Charlotte Department of Transportation

Memorandum

Subject: Rezoning Petition 15-014: Approximately 4.66 acres located on the northeast corner at the intersection of Park Road and Sharon Road.

Figure 1

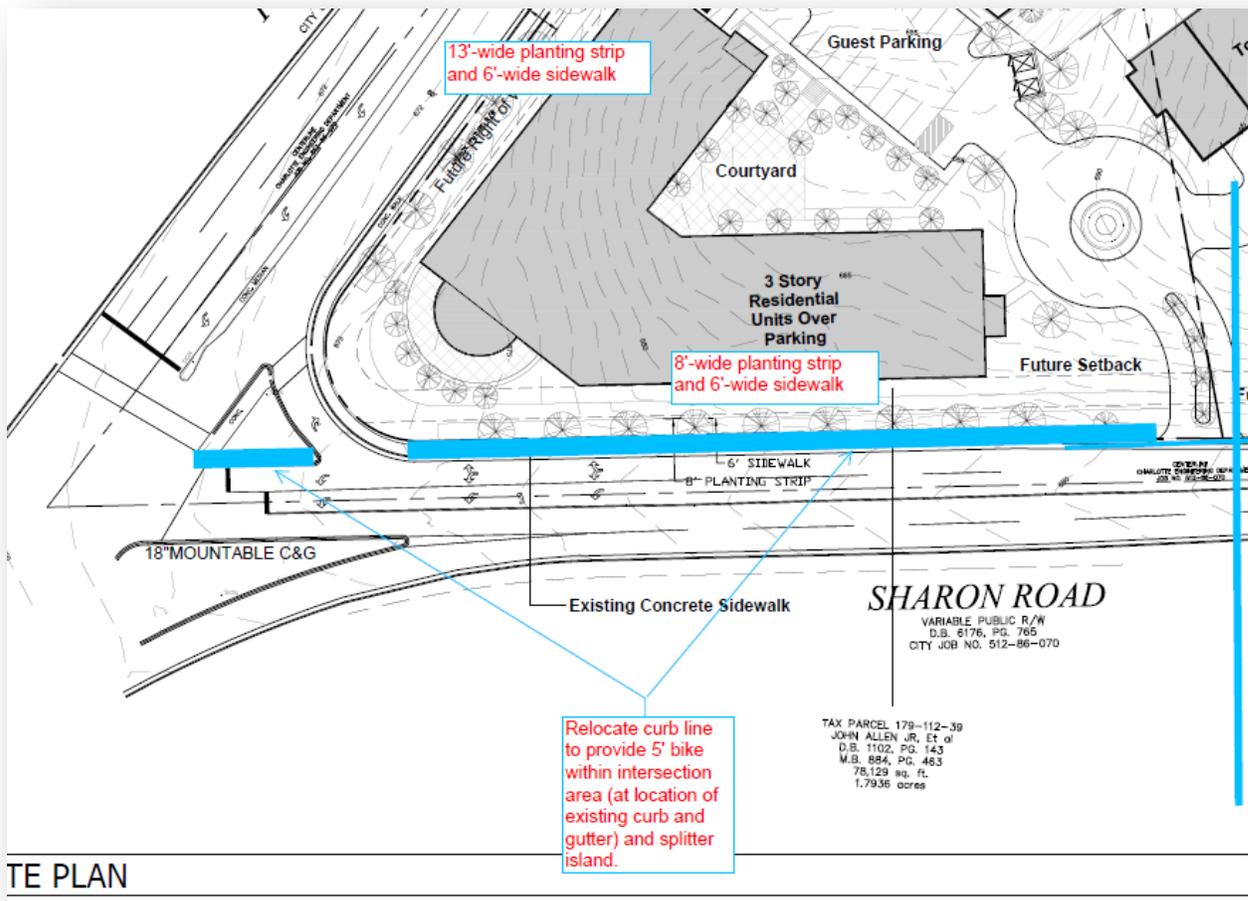
wide sidewalk. Thus, CDOT requests the following improvements along the site's Sharon Road frontage.

- a. At the intersection of Park Road along Sharon Road within the existing splitter island, relocate the curb line to create a 5'-wide bicycle lane.
- b. Along the existing site's frontage where curb and gutter is present, relocate the curb line to create a 5'-wide bicycle lane.
- c. Establish the new back of curb location at 24' from centerline where curb and gutter does not exist.
- d. Along the entire Sharon Road frontage, establish an 8'-wide planting strip and 6'-wide sidewalk.

See the Figure 1 and Figure 2 below.
